ADDENDUM NO. 3

Client: City of Elwood
Municipal Building Renovation

Issue Date: November 2, 2026

SHEET NUMBER:
A103

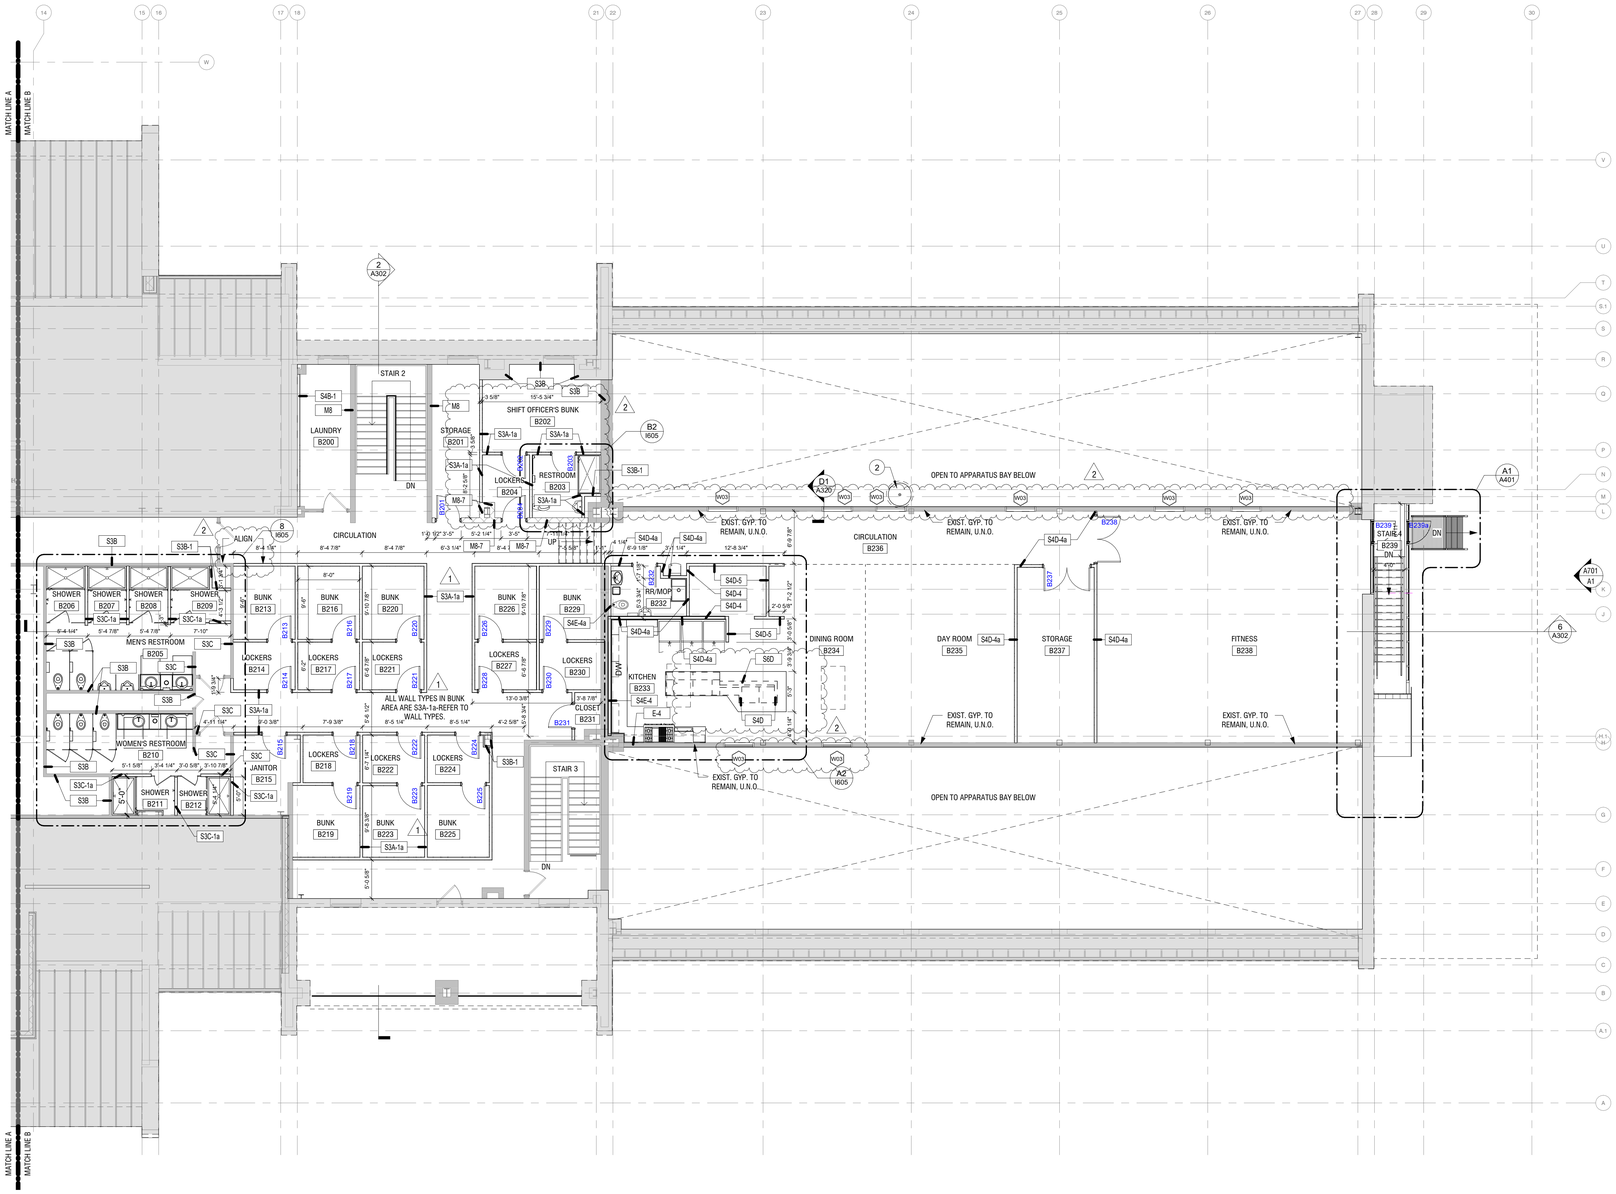
7. **Sheet No. A103 – Area "A" – Second Floor Plan**

a. Add Floor Plan Legend
    b. Revised View Names

SHEET NUMBER:
A104

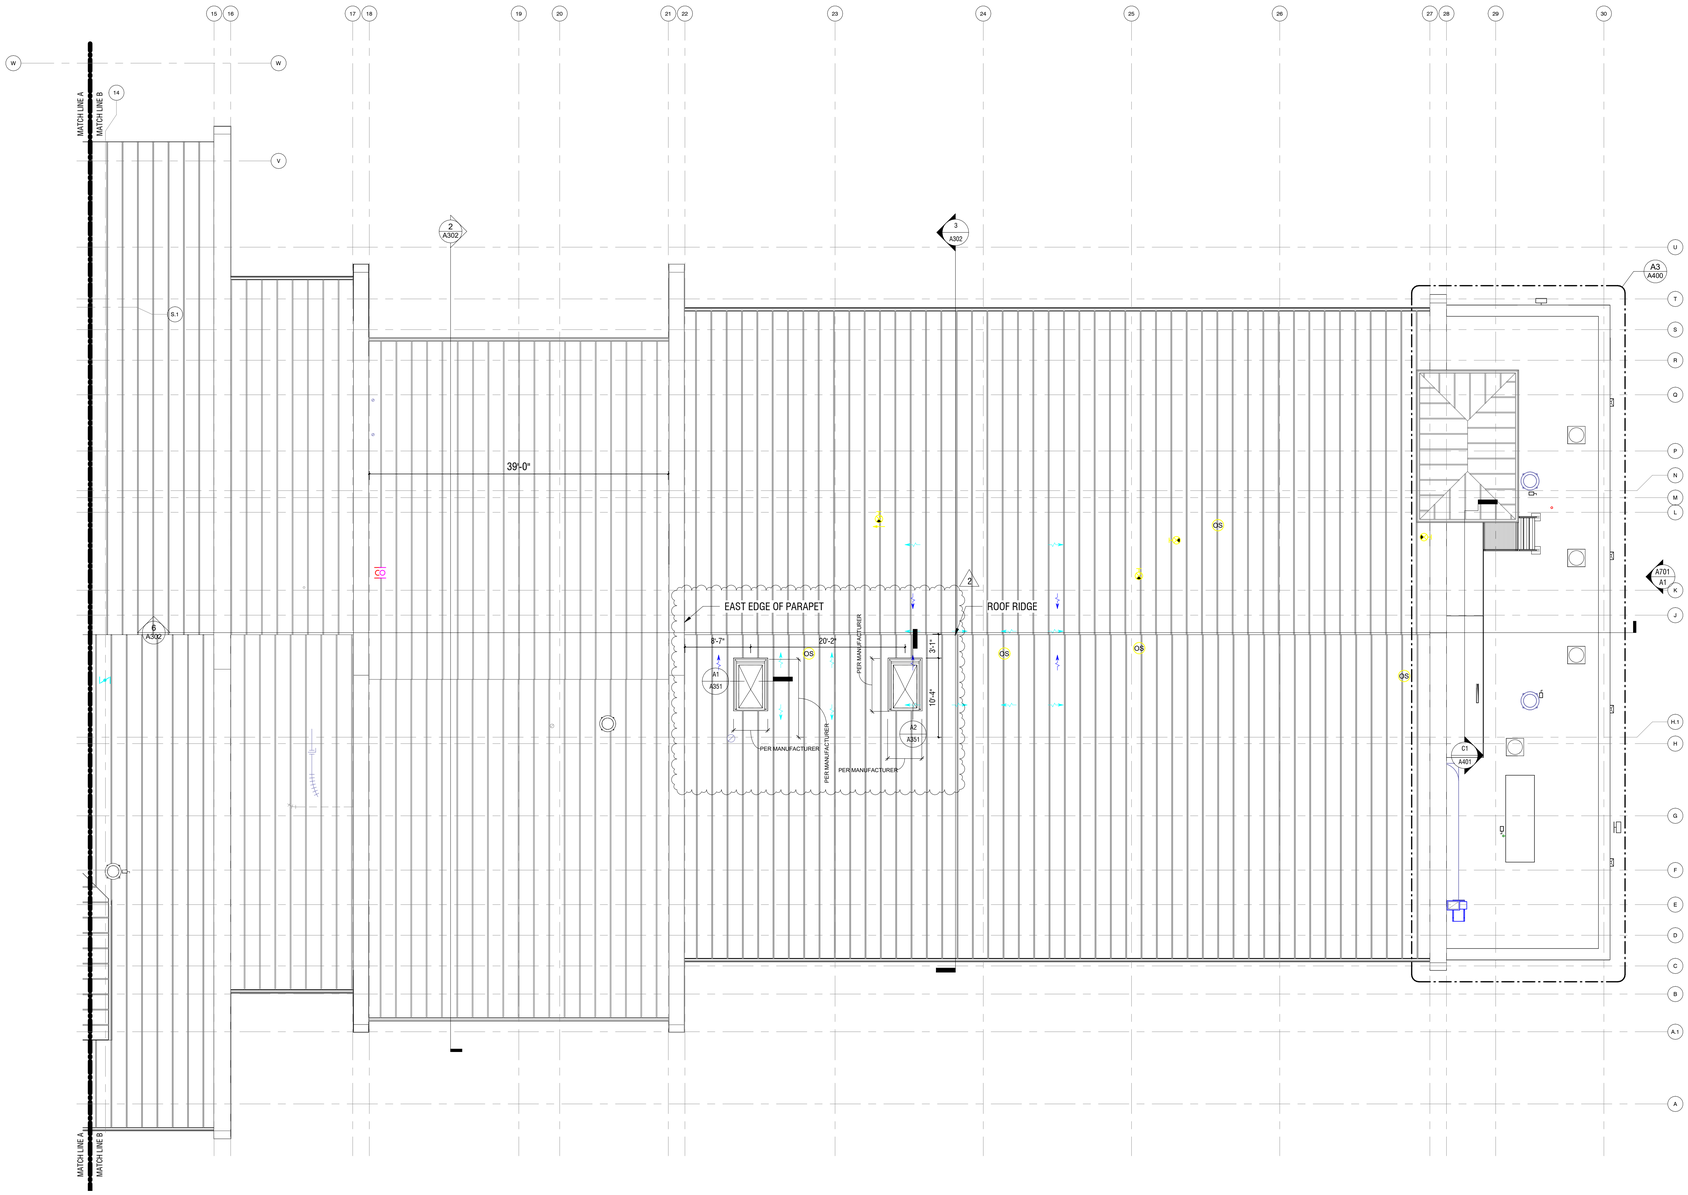
8. **Sheet No. A104 – Area "B" – Second Floor Plan**

a. Add Floor Plan Legend
    b. Revised View Names
    c. Added walls tags under kitchen island
    d. Revised Window tags W03

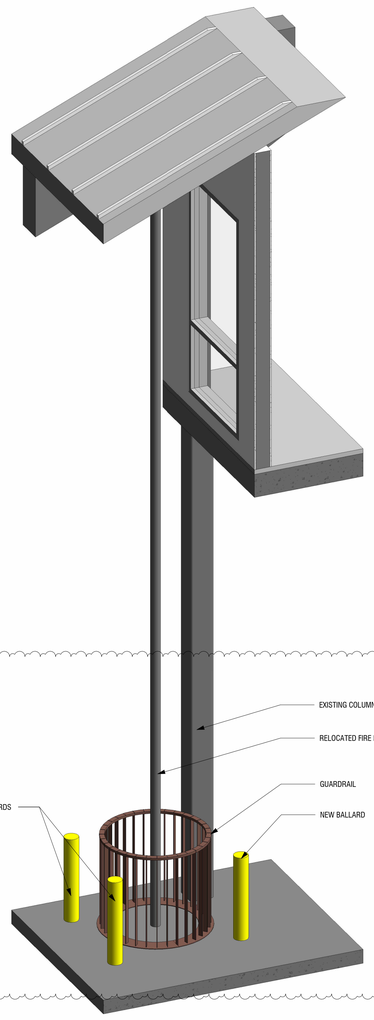
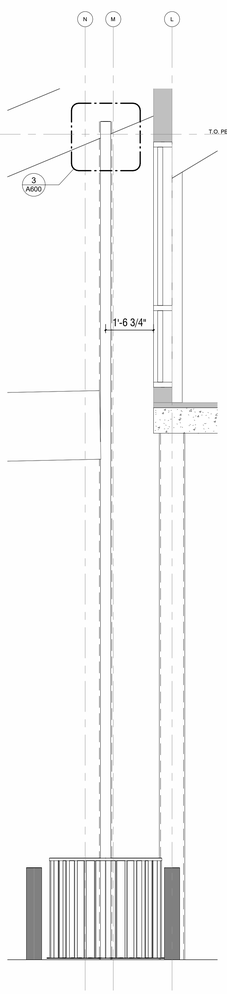
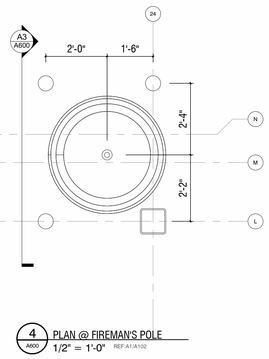
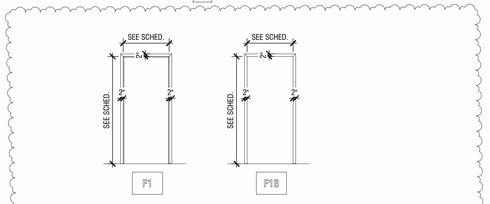
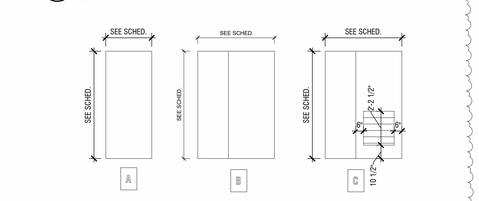
10. **Sheet No. A600 – DOOR & WINDOW SCHEDULES, ELEVATIONS**

a. Added Details A1/A600 & B1/A600
    b. Added Fireman's Pole Notes for clarity
    c. Revised Door Elevations & Door Frame
    d. Revised Door & Frame Schedule

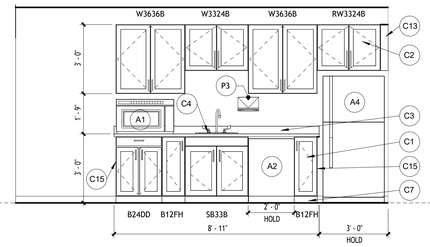
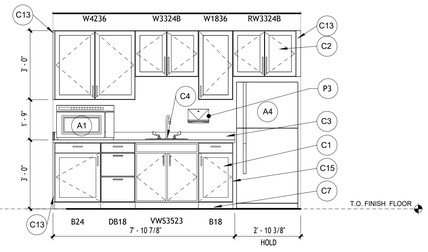
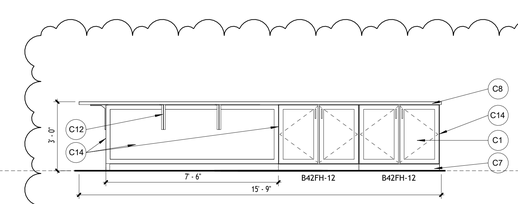
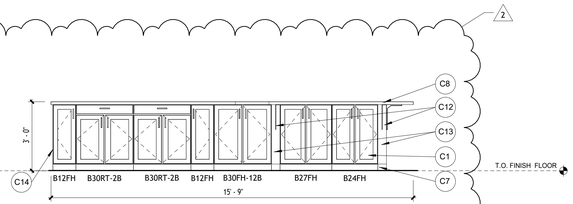
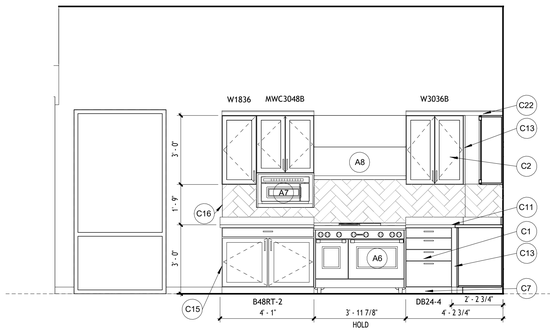
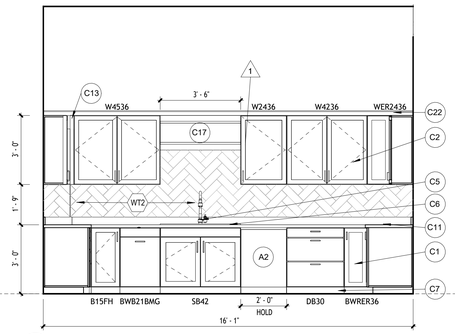
11. **Sheet No. I501 – Interior Elevations – Casework**

a. Added cabinet Shelf note
    b. Added two (2) cabinets under island, B27FH & B24FH

SHEET NUMBER: I600

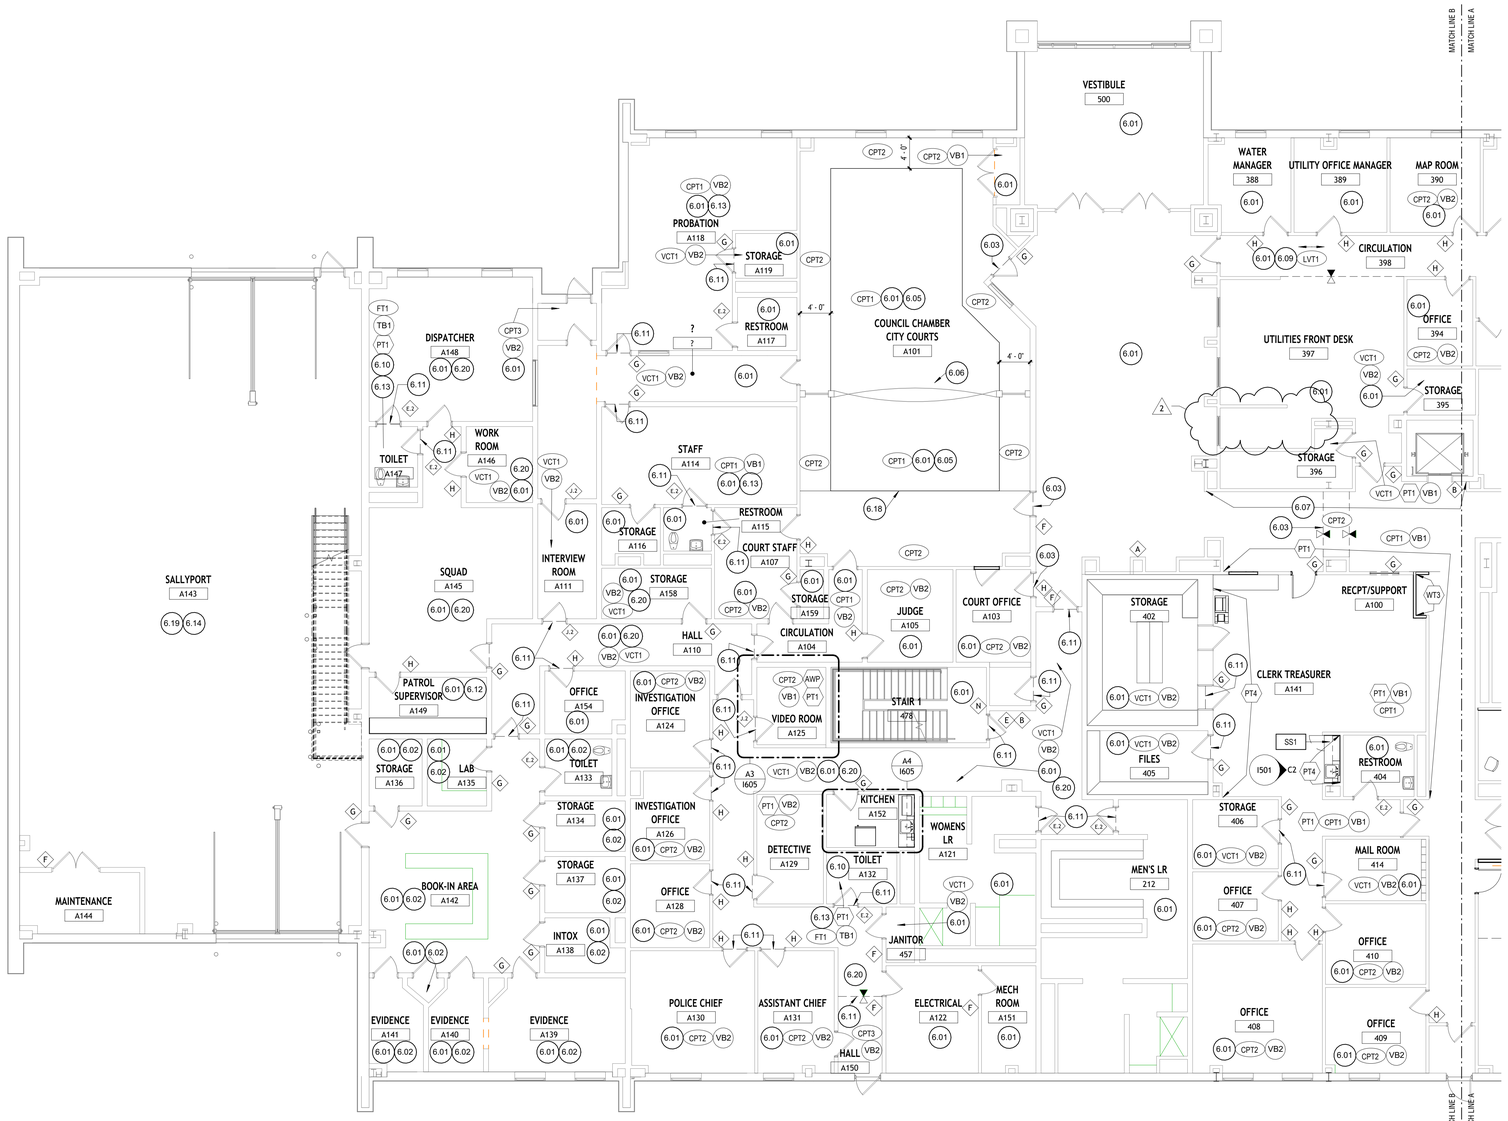
12. **Sheet No. I600 – Finish Plan - First Floor West**

a. Added corner guard note

SHEET NUMBER:
I601

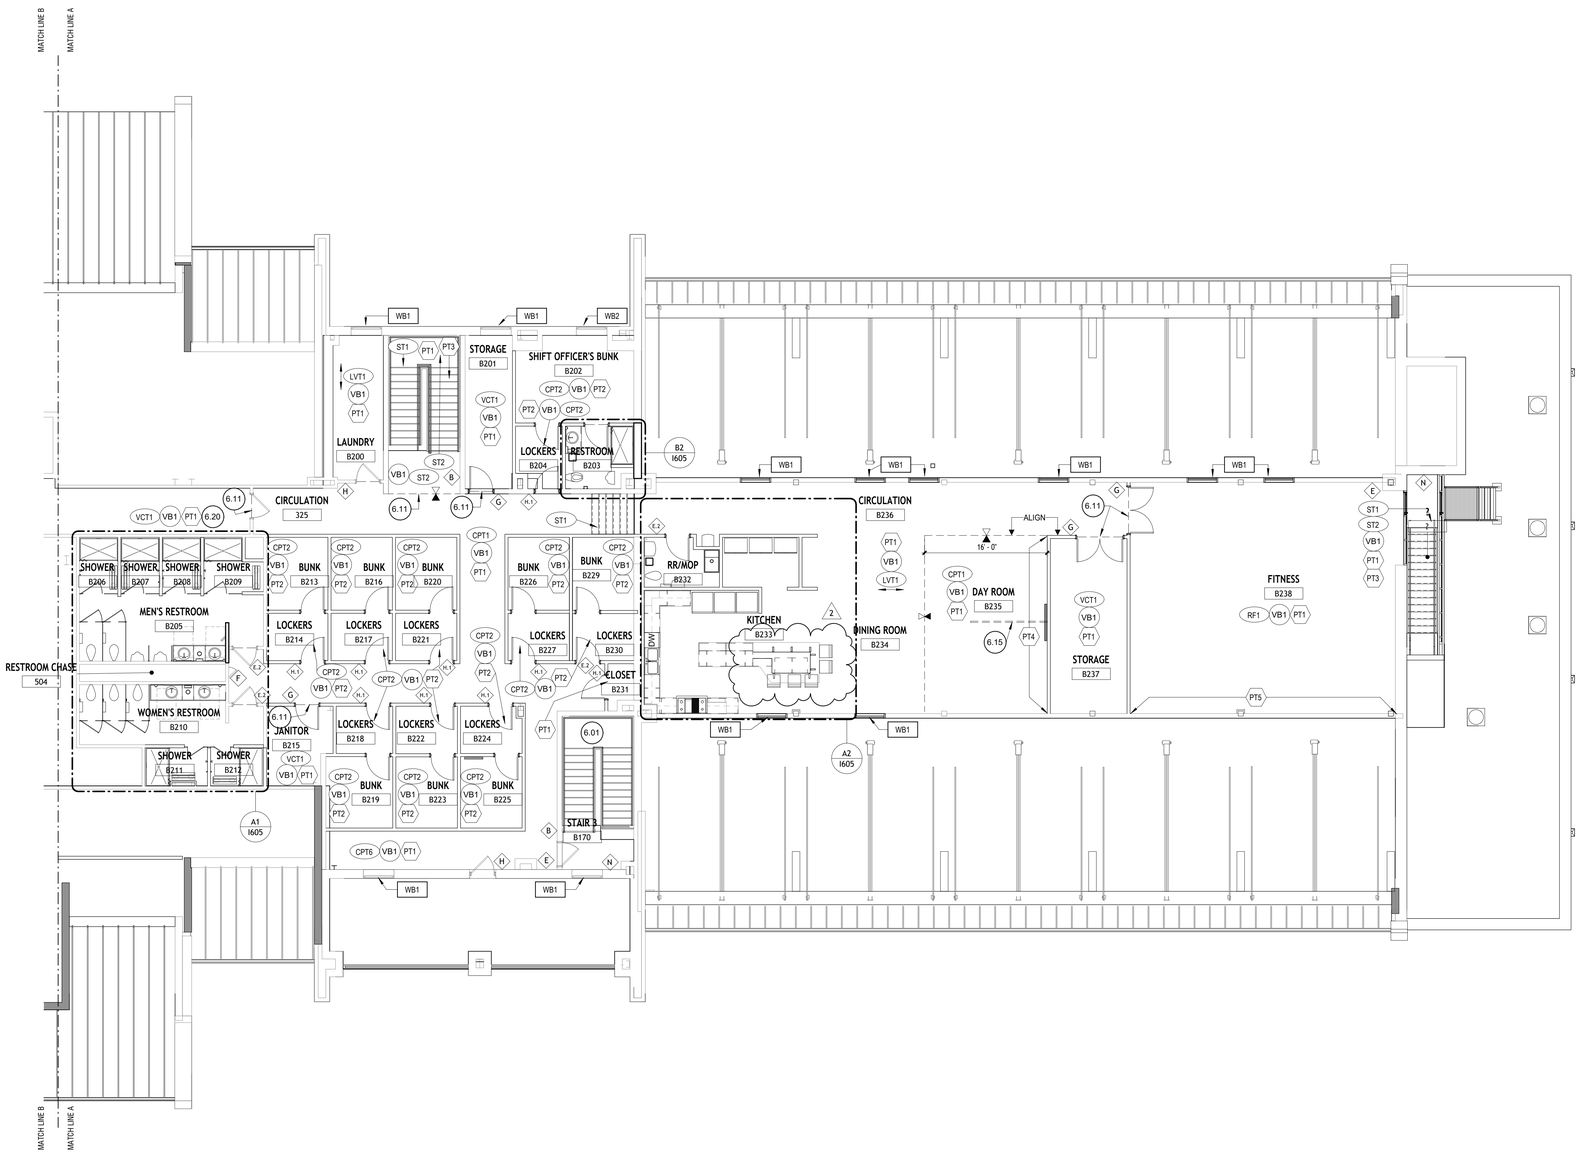
13. **Sheet No. I601 – Finish Plan - First Floor West**

a. Removed Keynotes 6.06, 6.08, 6.09, 6.21
    b. Revised walls under cabinet

SHEET NUMBER:
M101A

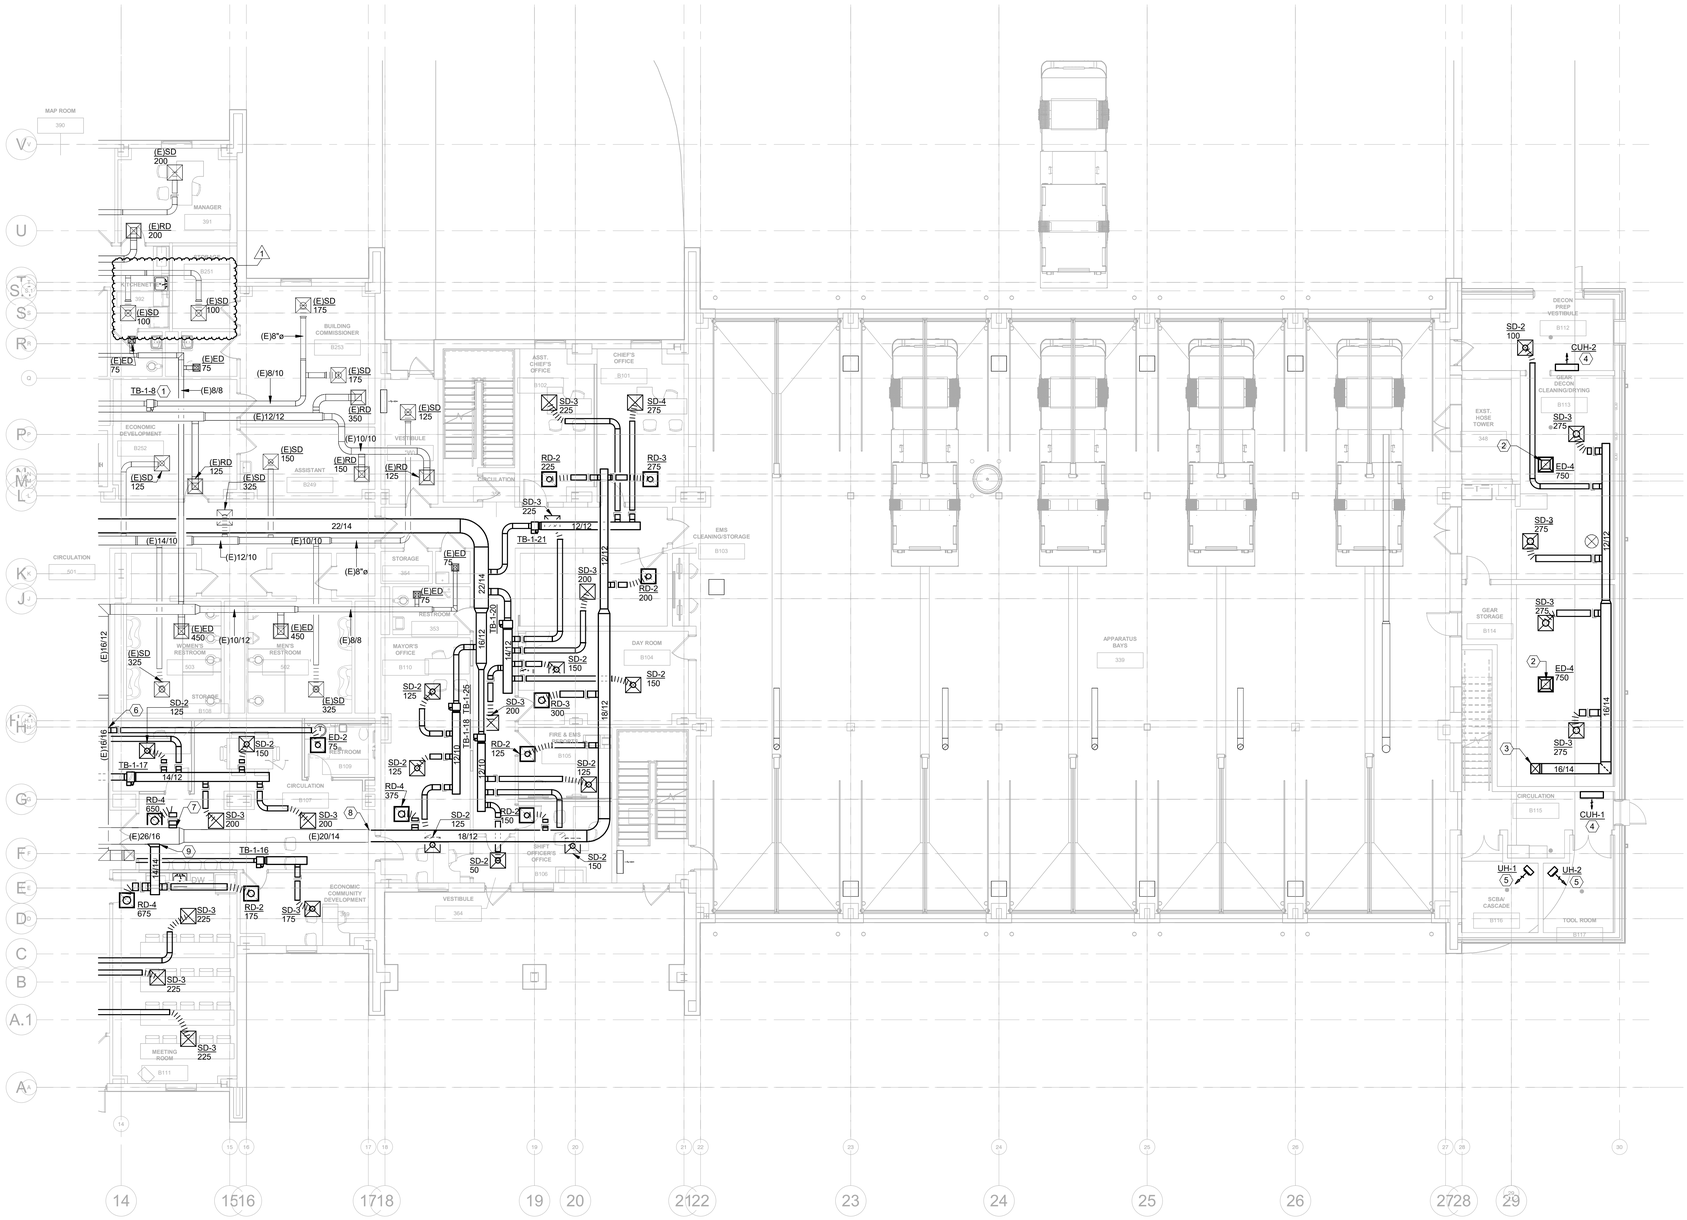
15. **Sheet No. M101A – 1ST FL Plan Mechanical – Area A**
